PERMIT MODIFICATION REQUEST
(VOLUME II OF II)
Reconfiguration of Block O

City of Nacogdoches Landfill
Nacogdoches, Texas
TCEQ Permit No. MSW-720

File No. 16209006.26 | January 2024

Attachment No. 6
Redline/Strikeout Pages

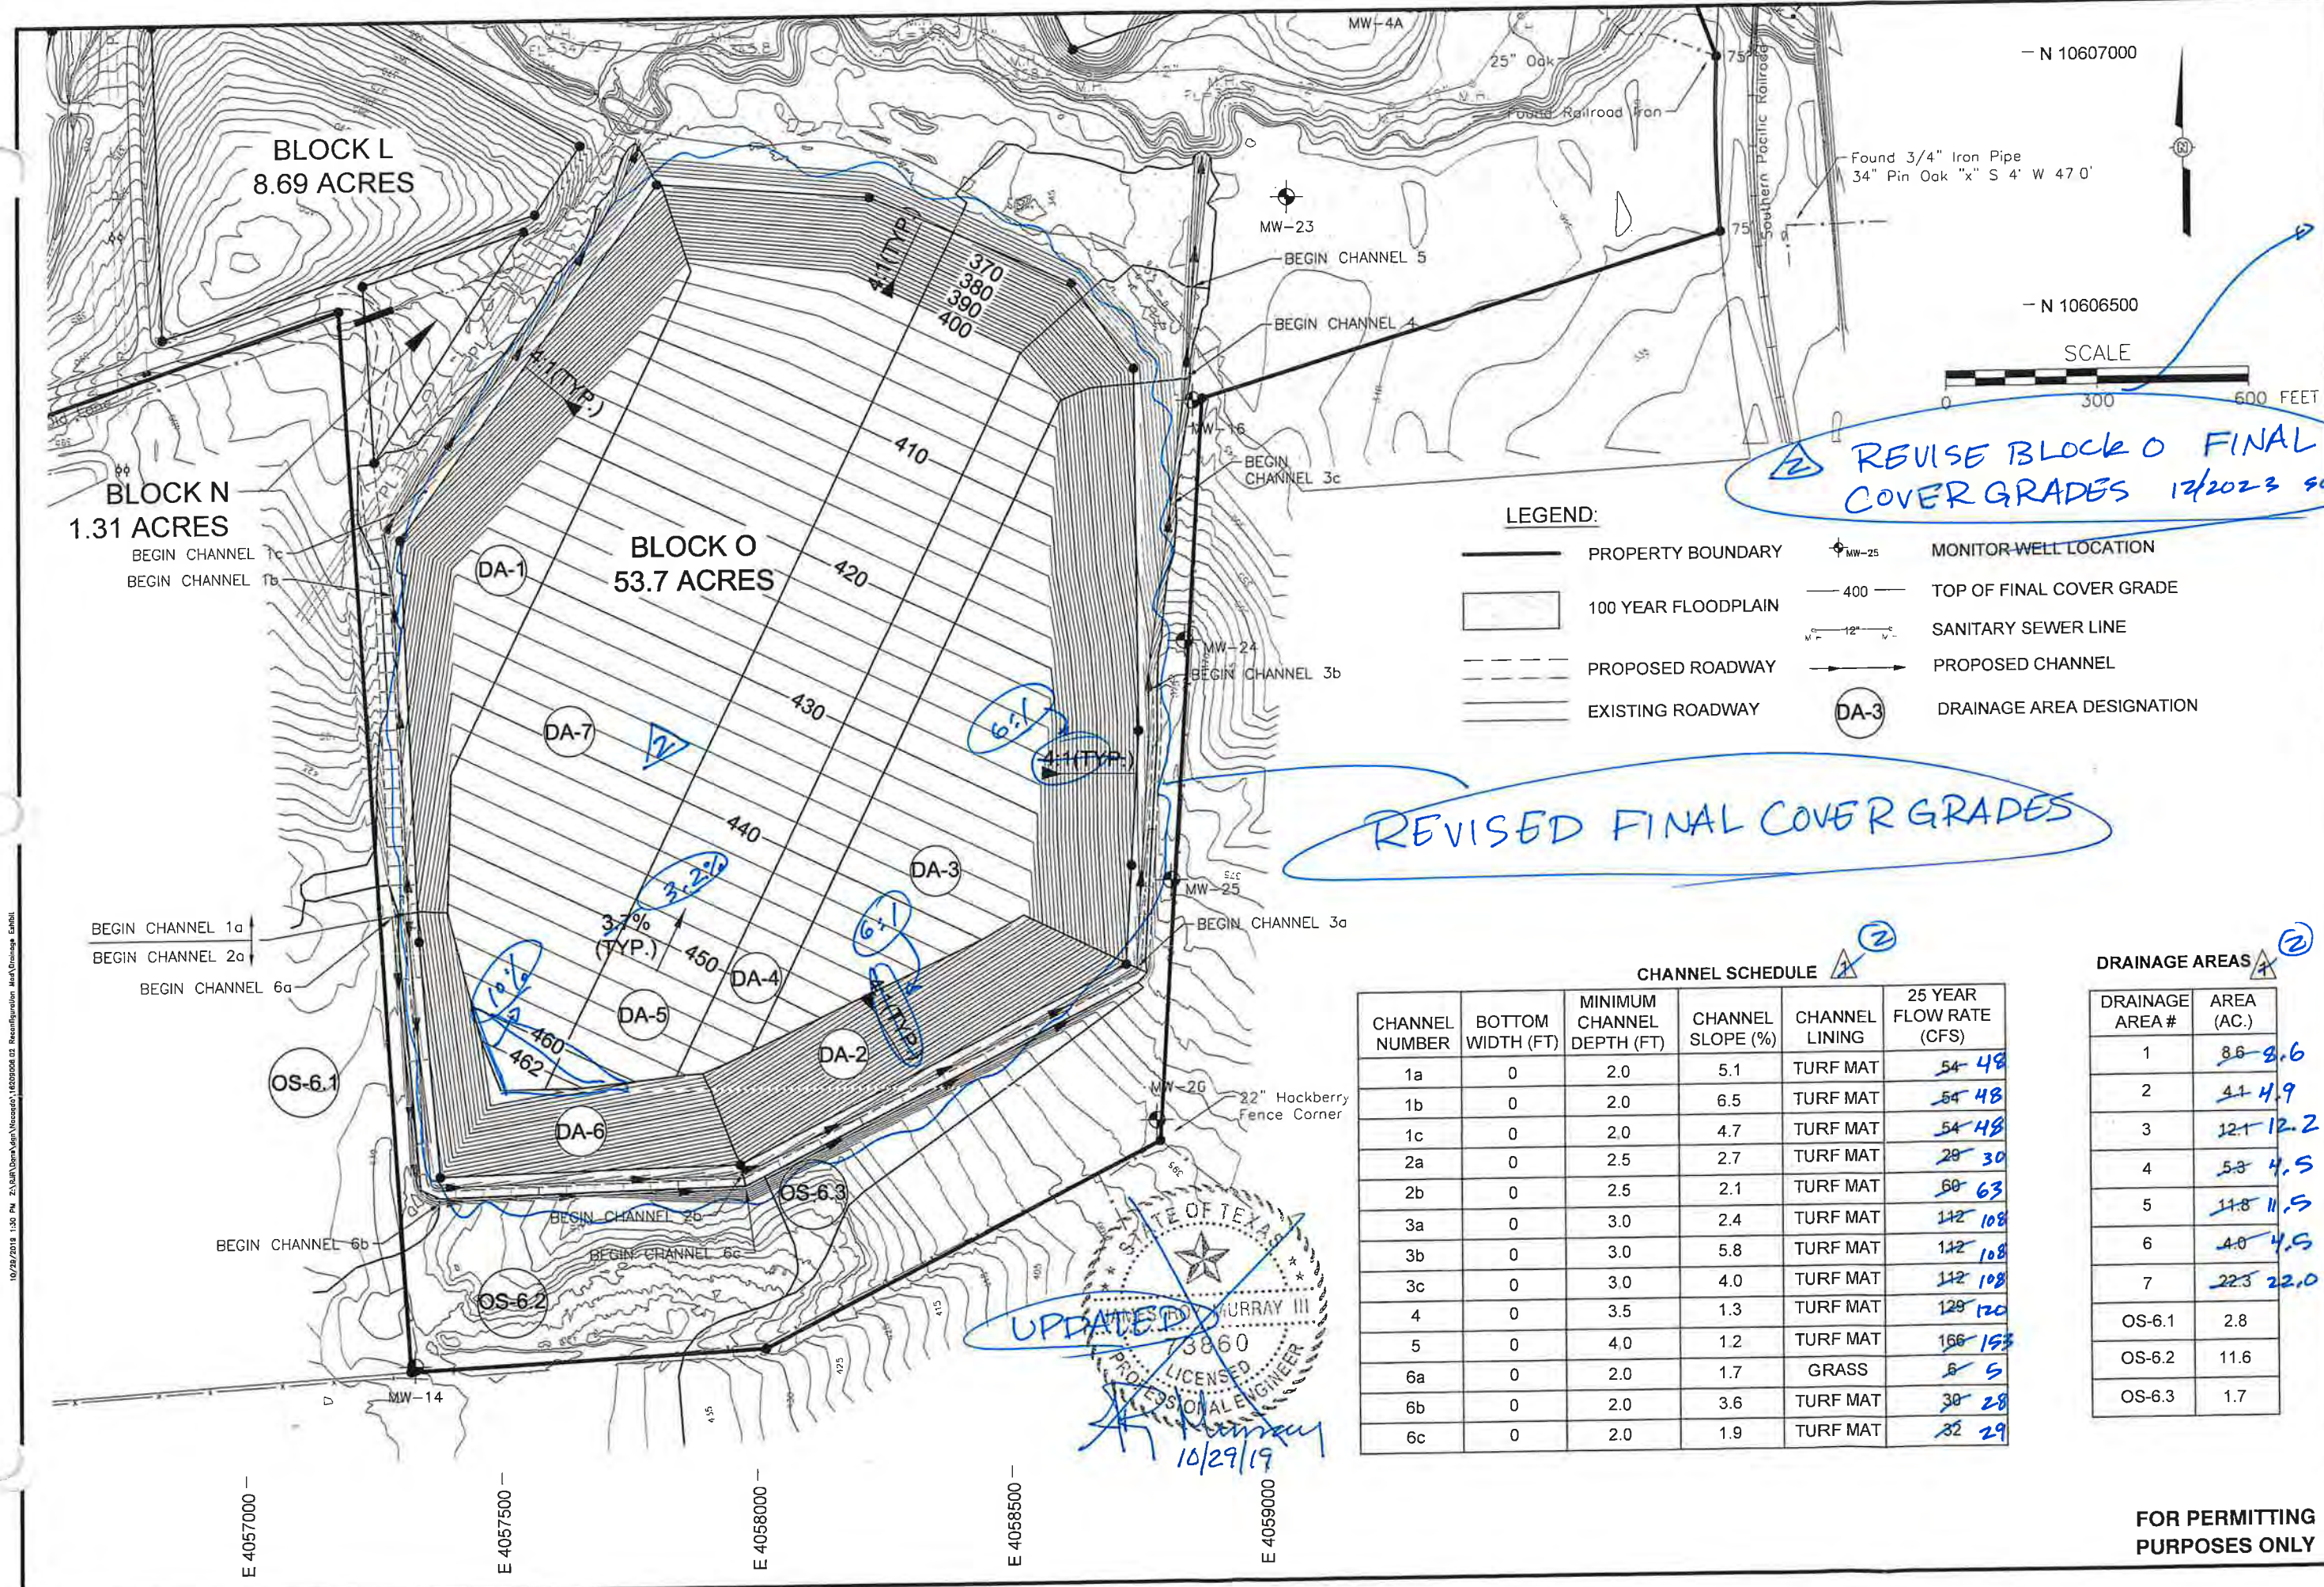
REVISION BLOCK O FINAL COVER GRADES 12/2023

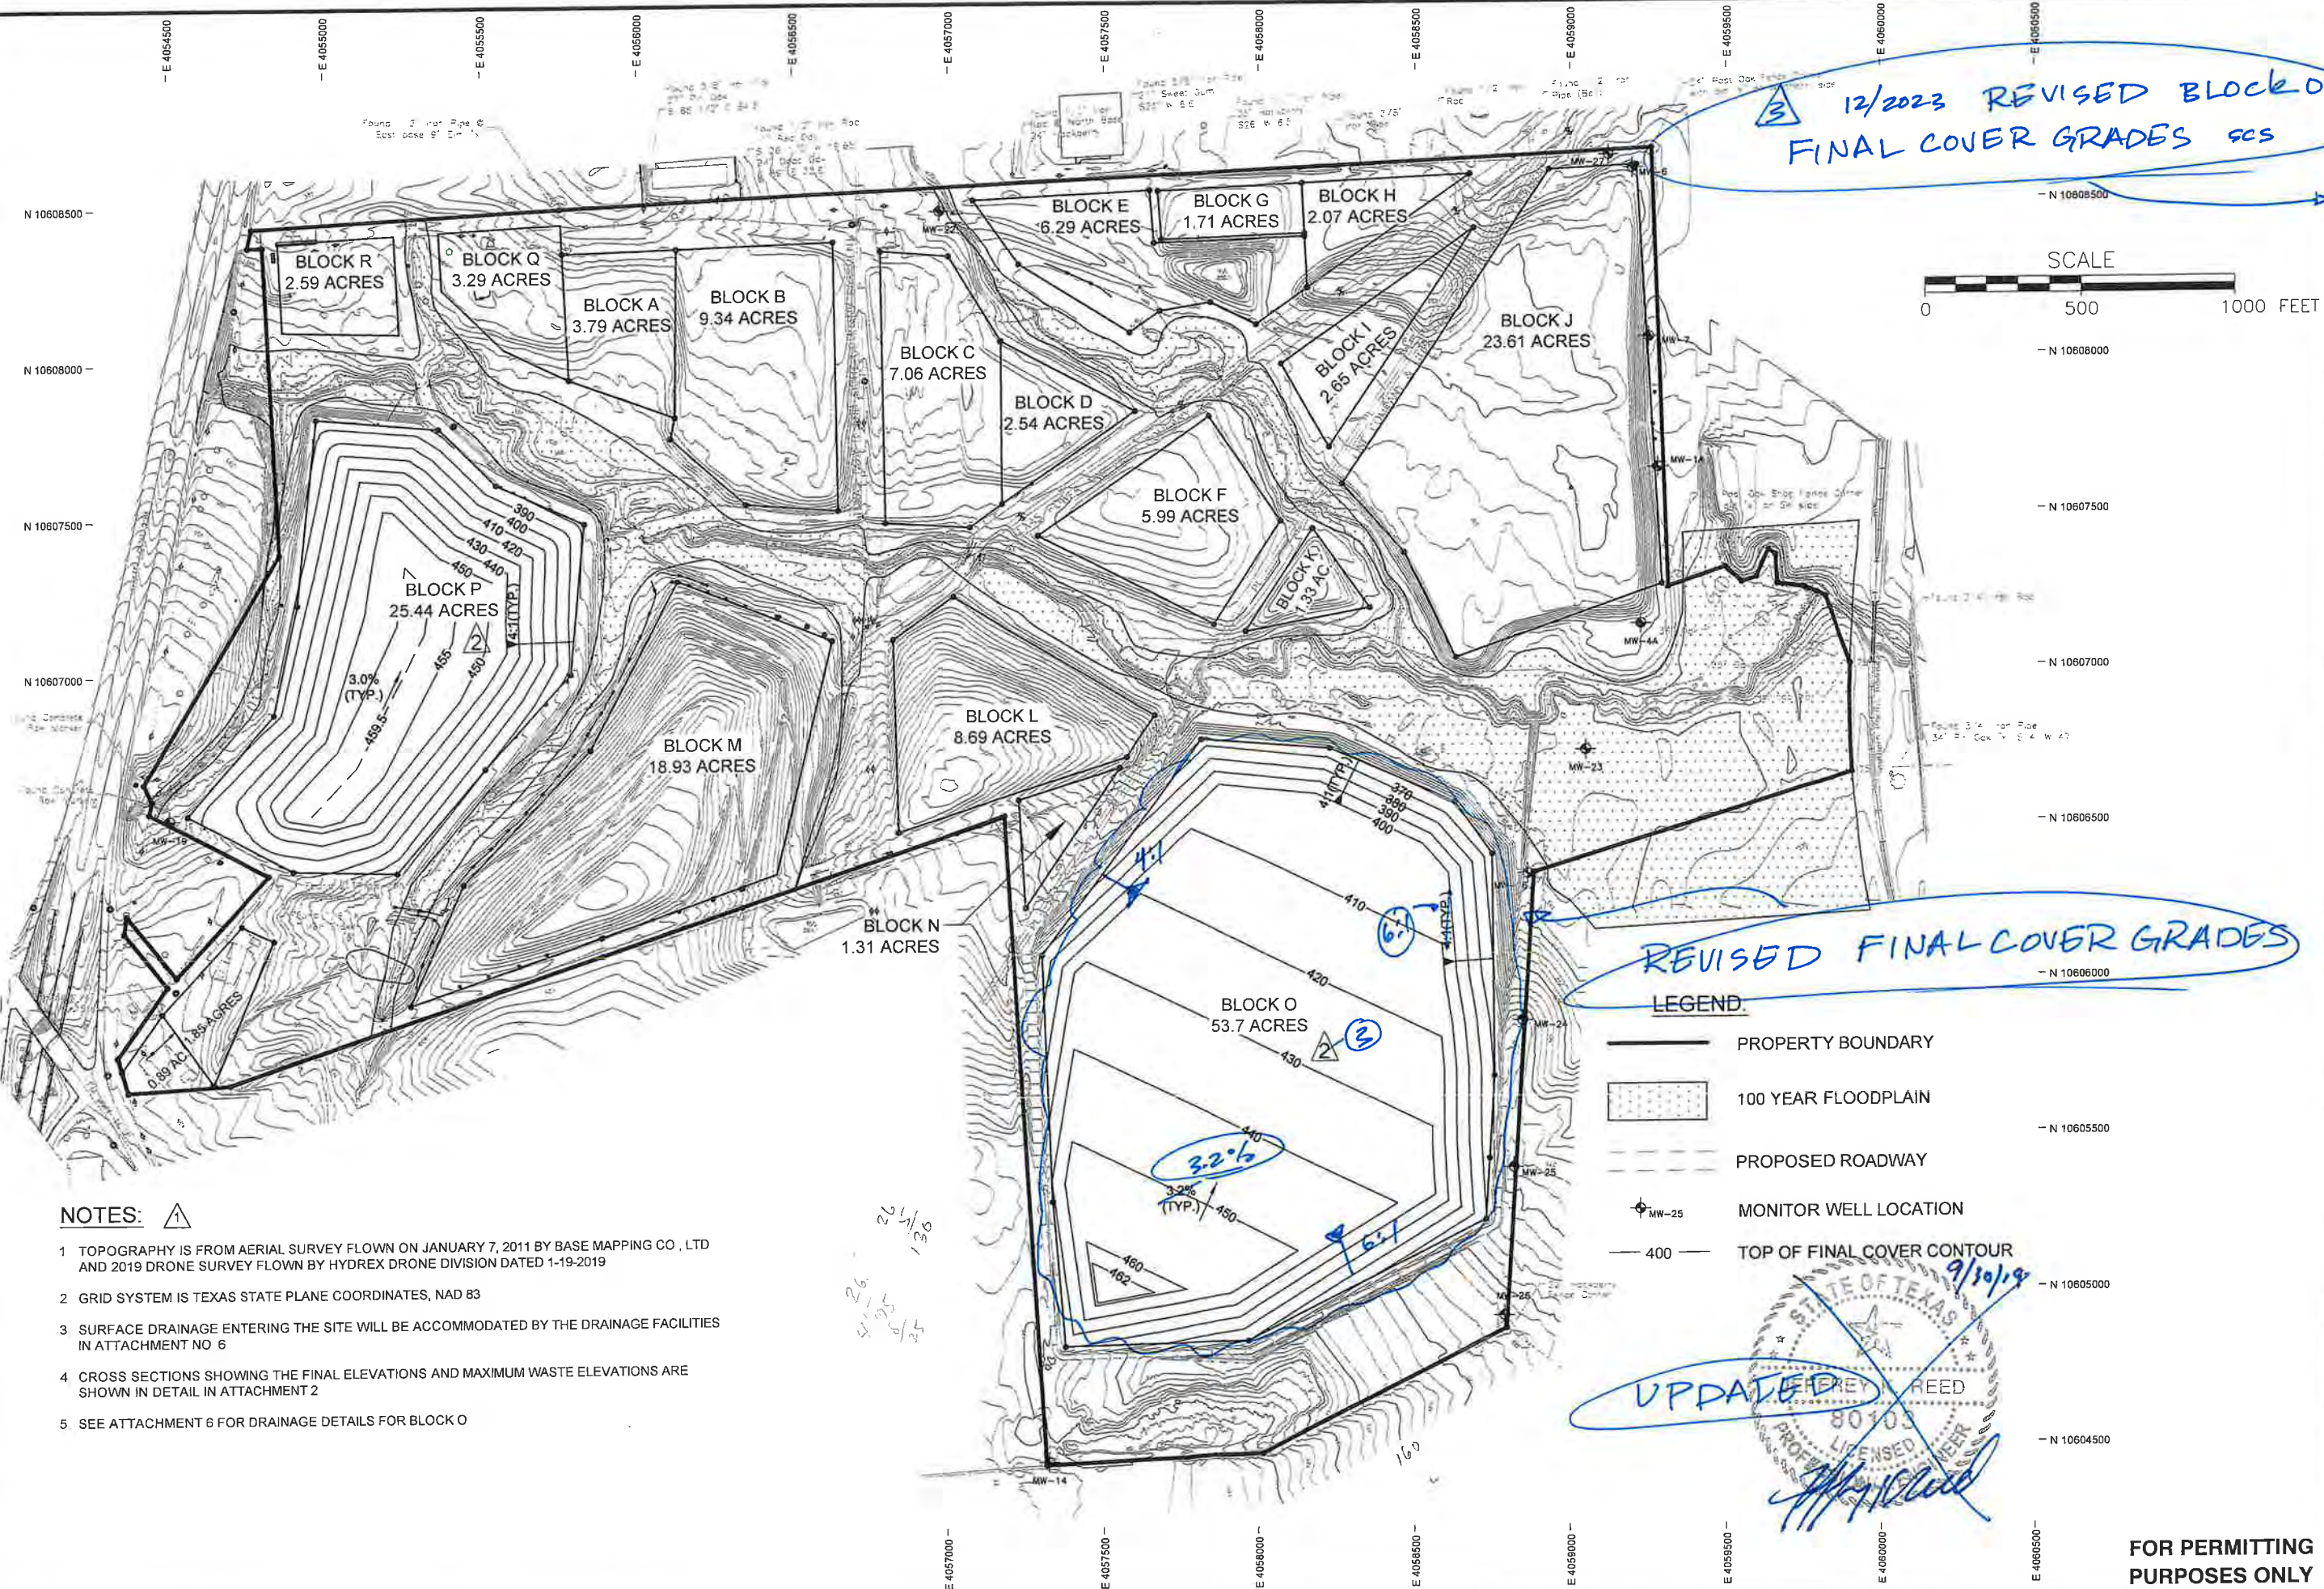
12/2023 REVISED BLOCK O
FINAL COVER GRADES SCS
